**THE COUNCIL OF THE CITY OF
COVENTRY (CITY CENTRE SOUTH)
COMPULSORY PURCHASE ORDER 2022**

**INSPECTORATE REFERENCE
APP/PCU/CPO/U4610/3299063**

**PROOF OF EVIDENCE OF ALEC
PHILPOTT IN RESPECT OF SERVICING**

Job code:	RLAMCorporationSt.1
Prepared by:	Alec Philpott
Issue Date:	23rd December 2022
Status:	Final

Figure 4.2: TPP Service Strategy for Block A2 (Source: TPP Draft SMP)

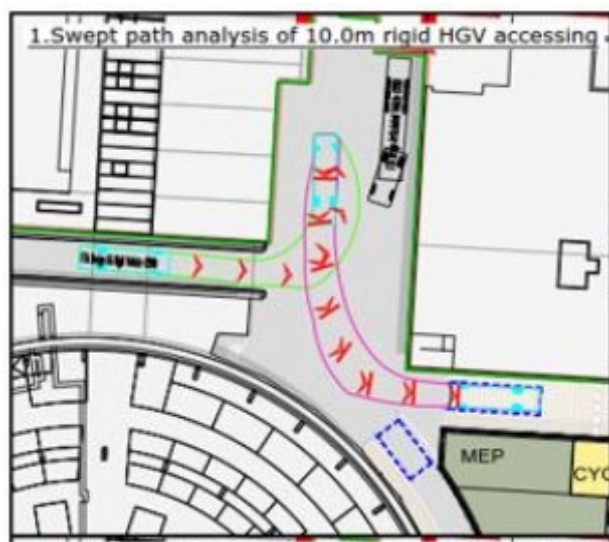
- 4.21 As per the TPP tracking in **Figure 4.2** above, TPP are promoting servicing adjacent to Block A2 (within Yard C), sandwiched between Block A2 and either CM (to its west) or Poundland (to its north).

- 5.51 In their analysis [*May 2022 Draft SMP – Page 9, Tables 4.1 and 4.2*], TPP report LGV and HGV trips associated with the proposed residential use in Block A2 and title the table “servicing trips”.

- 5.55 Consequently, TPP’s assessment has underestimated the servicing activity of Block A2 residential by circa 20%.

- 7.20 The only available mitigation for the deficiencies associated with Block A2, as proposed, is to amend the layout of service Yard C to provide a sufficiently sized servicing area and loading bays which preserved pedestrian safety and does not compromise emergency access, or to omit Block A2.
- 7.21 The AA should demonstrate how the provision of such a servicing yard can be achieved, or Block A2 should be omitted from the scheme.

Figure 5.1: Area of Land to be Acquired, Required for LPSC Service Vehicle Manoeuvring

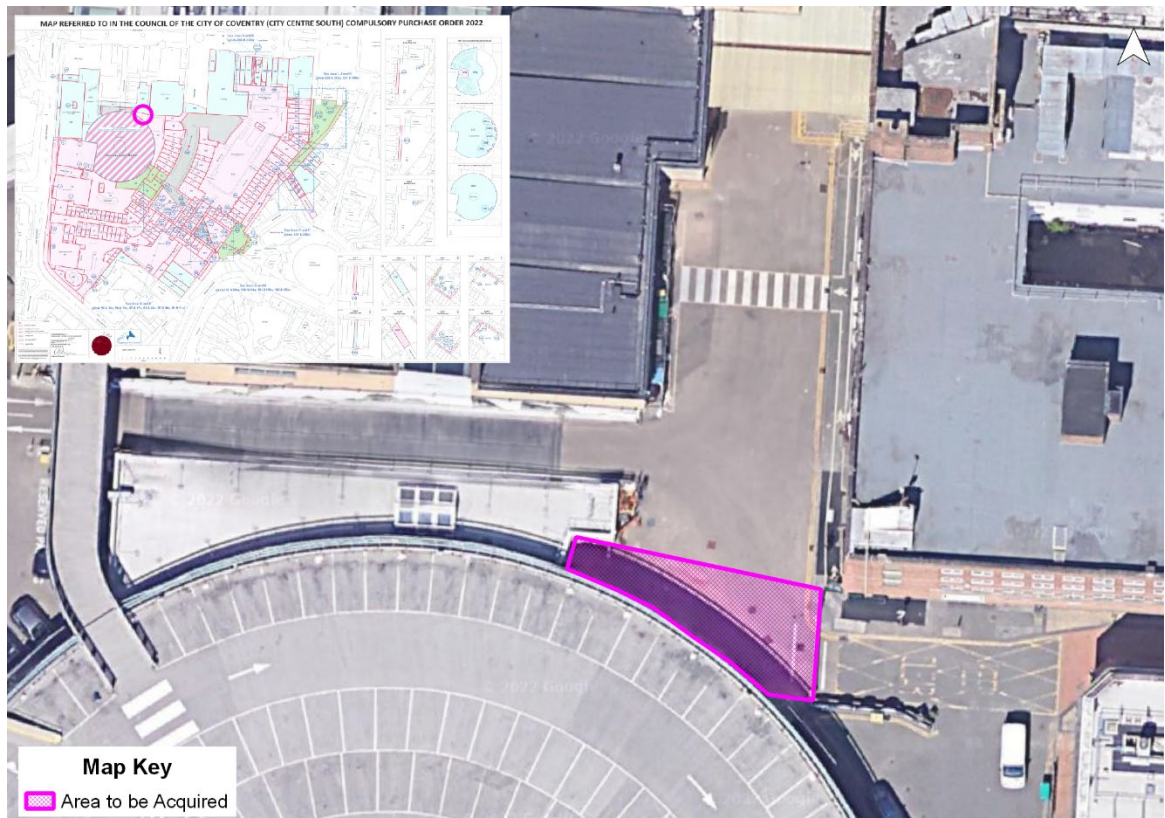
- 5.1 The Compulsory Purchase Order map identifies an area of the LPSC service yard “to be acquired”, immediately adjacent to the northeast corner of CM as shown in **Figure 5.1** below. This area forms part of plot 54 on the CPO plan.

- 5.2 The area identified is presently used to enable delivery and servicing to occur to the LPSC and acts as essential manoeuvring space to permit vehicles to back up to the 3no. dock levellers at the north of this service yard.
- 5.3 **Drawing AP1** appended hereto illustrates the swept path manoeuvres which are presently possible and, for ease, identifies the “area to be acquired” in question.
- 5.4 The AA’s intention with this area to be acquired is presently unclear, but any development which would prohibit its use by delivery vehicles trying to access LPSC would prejudice the retailers operations.

- 6.1 In relation to the acquisition of land at the southern end of Service Yard B, the proposed CPO has the potential to prejudice servicing of the LPSC retailers.

- 6.2 If access over the land to be acquired is not provided to LPSC retailers, then this would result in the need for them to service using smaller vehicles or undertake multiple forward/reverse manoeuvres within the service yard.

- 6.4 For safety reasons it is generally accepted that reverse manoeuvres by delivery vehicles should be kept to a minimum (and preferably eliminated completely). If, as a result of the loss of the land to be acquired, it is necessary for vehicles to undertake multiple manoeuvres then this would require an appropriate risk assessment by each affected retailer although there can be no doubt that multiple manoeuvres are less safe than the single manoeuvres presently achievable.

- 5.5 The AA will need to provide an undertaking that use of this area by LPSC retailers for legitimate servicing manoeuvres will not be prohibited in the future or this area will need to be removed from the proposed CPO.

- 7.1 The AA should be required to ensure that service vehicles utilising Yard B are able to pass over the area identified in **Figure 5.1**, or be required to remove this area from the CPO in order to preserve appropriate servicing for LPSC retailers.

Figure 5.2: Proposed Service Area Locations

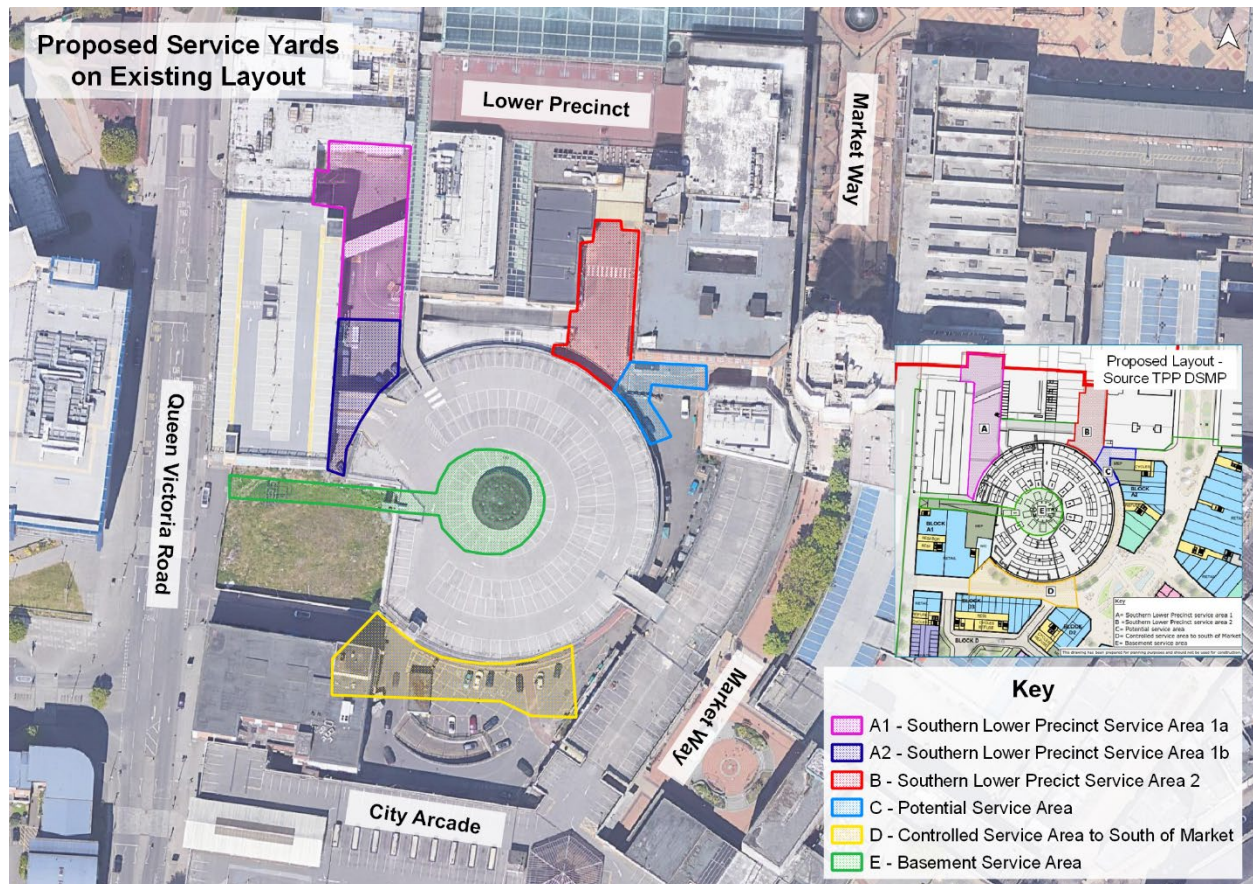
5.7 **Figure 5.2** below identifies the approximate areas of each of the service yards, post development with a description of the changes below:

- Yard A – No Change from existing
- Yard B – No Change from existing
- Yard C – reduced in scale to accommodate footprint of Block A2 and intended to also serve solely proposed Block A2
- Yard D – reduced in size and servicing access time restricted to 0600/0700-1000 hours only
- Yard E – 4no. small basement service bays proposed, accessed from a new ramp from Queen Victoria Road

- 5.32 The above table identifies that if CM and LPSC are 100% occupied and any excessive dwell time is curtailed to two hours, the service vehicle accumulation will reach the maximum number of bays available (1000 hours). If dwell time is not curtailed, then the demand exceeds the supply for an extended period of the day.

- 7.5 Given the results of the analysis, it is considered that the best way to seek to mitigate adverse impact and manage future service yard activity would be to implement a booking system across the entirety of the affected service yards. While this solution would theoretically result in controlling the timing of deliveries to each yard such that the supply of loading bays is not exceeded, it will only provide a degree of mitigation against the potential issues that could arise, and would rely upon additional resourcing and infrastructure being made available.

Figure 5.4: Block A2 Proposed Loading Bay Locations

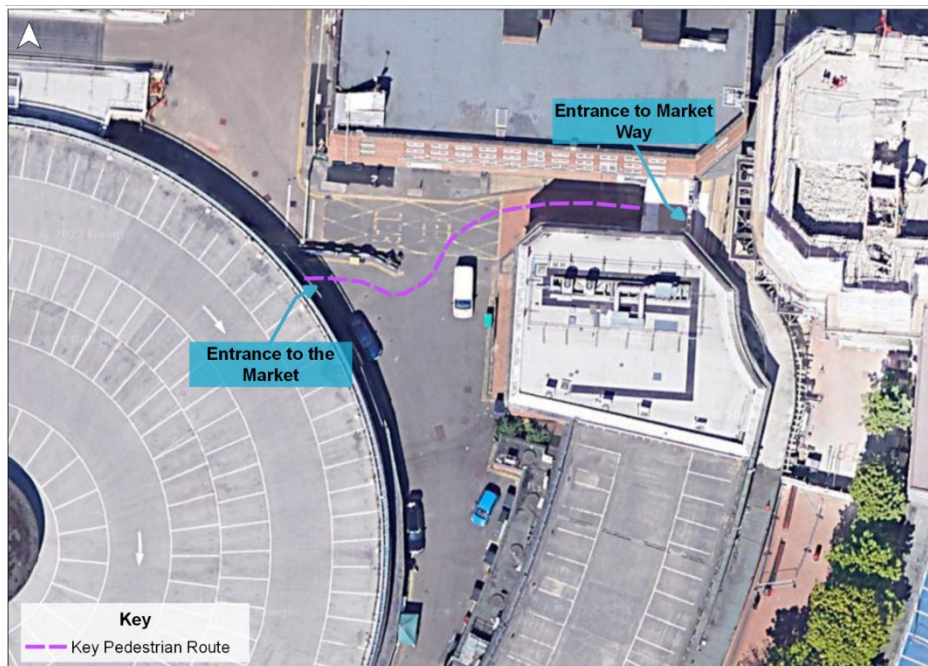
- 5.61 These bays are located immediately adjacent to one of the main Market entrances which acts as a key pedestrian link between the Market and Market Way (and beyond) as illustrated at **Figures 5.3 and 5.4** below.

- 5.63 The proposed northernmost bay sits on an area linking Market Way with the Market and Service Yards, (which is currently delineated with a yellow box and "Keep Clear" markings). This route has previously been illustrated by TPP as an area to be kept clear for emergency access. It would therefore follow that the provision of servicing in this location would be prejudicial to emergency access unless alternative access has been arranged.

- 5.64 While it is acknowledged that there is a level of servicing activity already occurring in proximity to this area, the entrance to the Market (and consequently emerging pedestrians) are presently offered some protection by a retaining structure and associated armco barrier shown in the photograph above.

- 5.65 This existing arrangement offers a safer environment for pedestrians to emerge (and to be seen) before accessing Market Way. This protection would be removed under the proposals in parallel with significantly reducing space for people to move.
- 5.66 The loss of this protective feature and compromise to emergency access is a significant safety concern as the service vehicle manoeuvres will include reversing within a far smaller space shared with pedestrians than presently occurs.
- 5.67 The proposed strategy for servicing Block A2 is therefore considered unsafe.

- 6.11 The previous section of my evidence identifies that the proposed servicing strategy for Block A2 is based on flawed calculations that under-estimate likely servicing activity. This will lead to an under-provision of servicing facilities in this area that could result in unacceptable overspill of servicing into adjacent areas, prejudicing the ability for servicing to occur in those other yards.
- 6.12 In addition, the proposed laybys provided to service Block A2 are located such that they compromise pedestrian access to Coventry Market, resulting in an unacceptable and unsafe arrangement.
